MEMORANDUM

SUBJECT: LAND-2020-00891
Nelson Legacy Group – Project One
Site Plan Entitlement; APPROVAL

DATE: April 15, 2021

“Before and “After” Images Respond to Board’s Comment #1 – Northwest & Southwest Corner

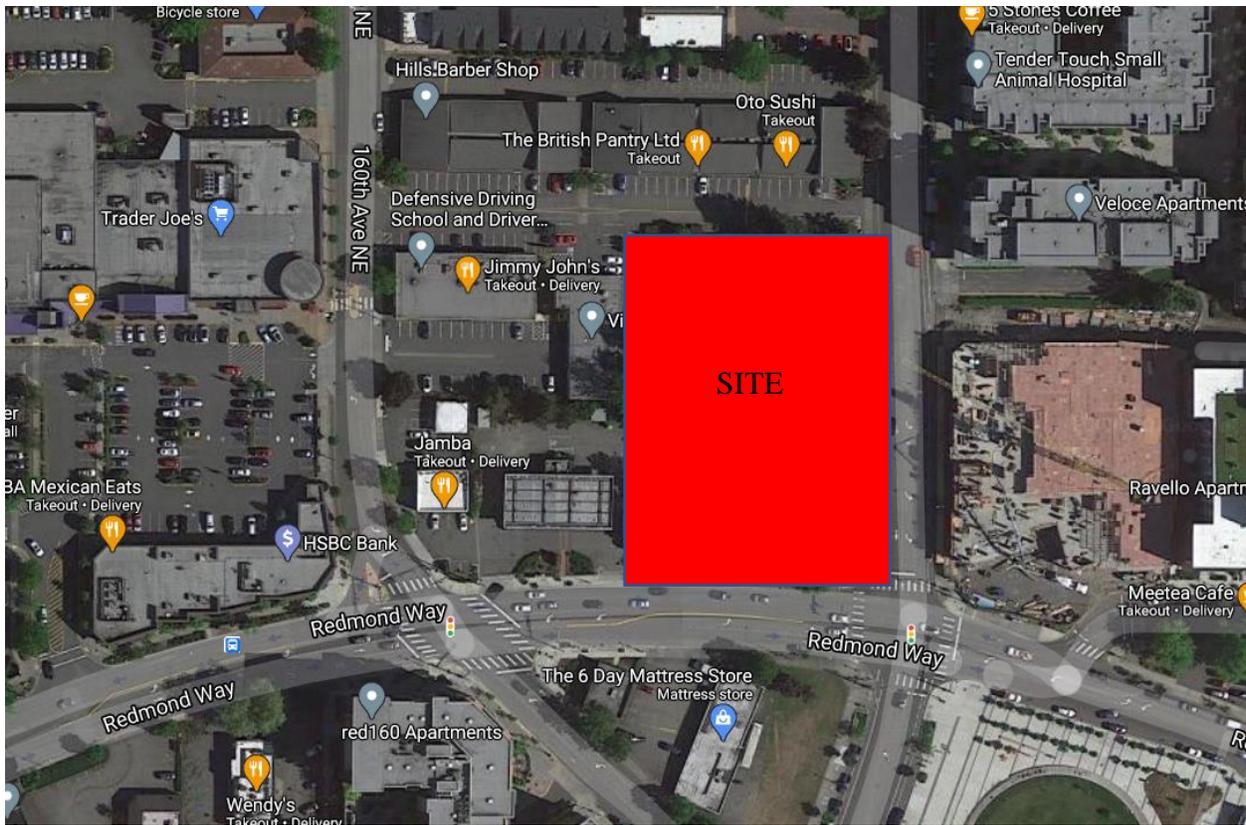
Comment/Response #1 – Northwest & Southwest Corner	
Board Comment: <ul style="list-style-type: none">• The Board felt that the height of the metal panels were unresolved and requested further analysis of the termination point at the northwest and southwest corners.• The Board indicated that the metal panels were a little low causing the upper parapet to feel heavy.• The Board suggested that the design team reference other architectural elements around the extent of the building to help locate a better termination point.	Applicant Response: <ul style="list-style-type: none">• The design team focused on the southwest and northwest corners. As a part of the analysis we studied the upper elements around the building.• Option A – The metal panels were raised 12-inches. This was an improvement and helped to reduce the weight of the upper parapet. However, there was no relationship with other elements of the building.• Option B - The team studied the metal panel with the lower parapet on the west façade and the addition of a horizontal panel joint. This felt like the most logical point of termination. However, the panel joint did not align with the roof deck soffit.• Option C – This option explored aligning the metal panel with the roof deck soffit and maintaining a consistent detail at the roof edge. Although this option seemed to work, the coping detail felt a bit heavy and lacked consistency around the building.• Preferred Option – The preferred option maintains a consistent language around the building and helps to reduce the weight of the upper parapet. The location of the metal panel and proportions of the adjacent fiber cement panel feel aesthetically balanced.

Staff response: Staff believes the applicant has effectively responded to the Board’s comment by evaluating and exploring multiple options. Staff agrees that the “preferred option” provides the best design balance as the weight of the parapet balances the metal panel and proportions of the adjacent fiber cement panel and effectively responds to the Board’s comments.

Images Respond to Board’s Comment #2 – Solar Study

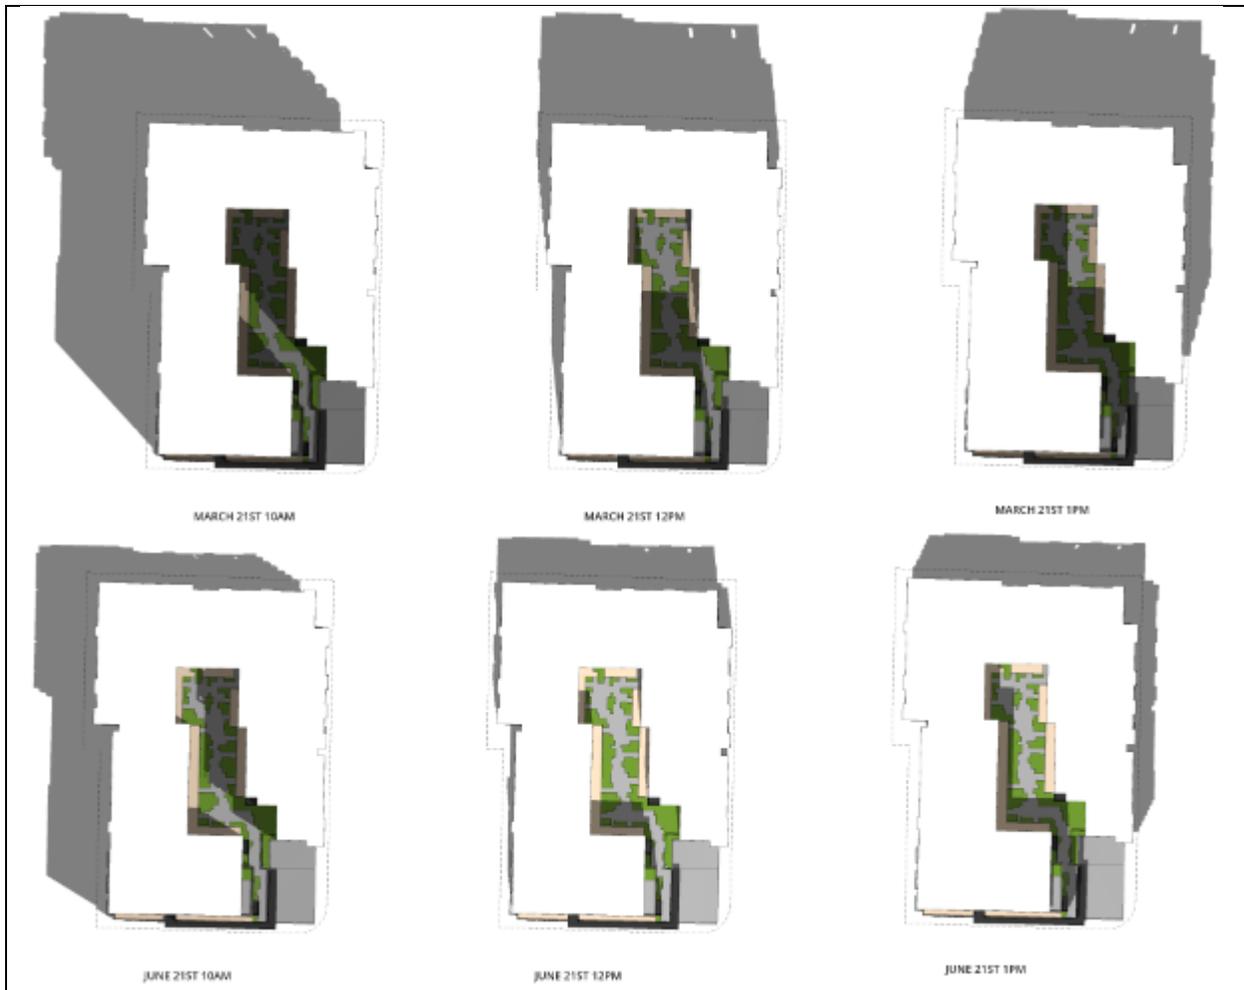
Comment/Response #2 – Solar Study

- Does the courtyard receive enough sunlight for planting? Can the design team provide a solar study?

- The solar exposure for the courtyard supports the proposed planting and provides a well illuminated space. From early March through late September, sunlight enters the courtyard in the morning and provides direct exposure from 10 am to 1 pm. Overcast skies are also present during this time, providing an even distribution of diffuse light. Overall, the courtyard receives good light conditions to help support the growth and life of the planting.
- The landscape designers used the solar studies to help select native ground cover species for the different light conditions and micro habitats.
- During the summer season, the sun angle is higher in the sky and provides more direct sunlight than in spring and fall. Sunlight enters the courtyard in the morning, but more surface area receives light due to the higher angle. We see good direct solar exposure from 8 am until 3 pm.

Staff response: Staff believes the applicant has effectively responded to the Board’s comment by evaluating solar studies in the courtyard in various seasons to ensure adequate lighting is achieved. The solar studies make it clear that the courtyard will receive ample sunlight in any season.
